Service-Information Motorcycle

46 032 91
(2451)

1991 R100GS Paris-Dakar New Low Front Fender

Fender Measurements:

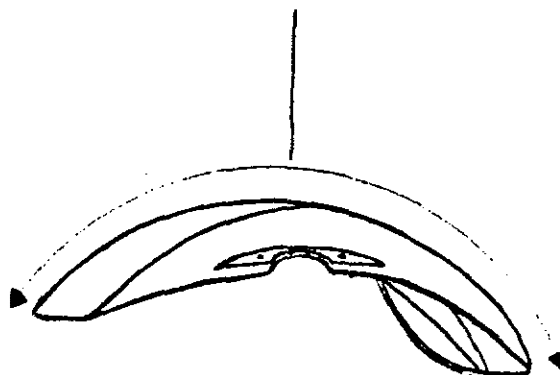
The new low fender is approximately 2 inches shorter than the one previously used on the 1989 and 1990 R100GS. Therefore, if your customer chooses, the new low fender can be mounted without any interference from the engine spoiler on 1991 model R100 P-D's.

With a tape measure, measure the fender tip-to-tip across the top.

New Fender - 1991 Model Year is 29 3/4" long

Old Fender - 1989 & '90 Model Year is 31 3/4" long

The bolt hole locations have also changed. Therefore, this new fender cannot be retrofitted to motorcycles prior to 1991 models.
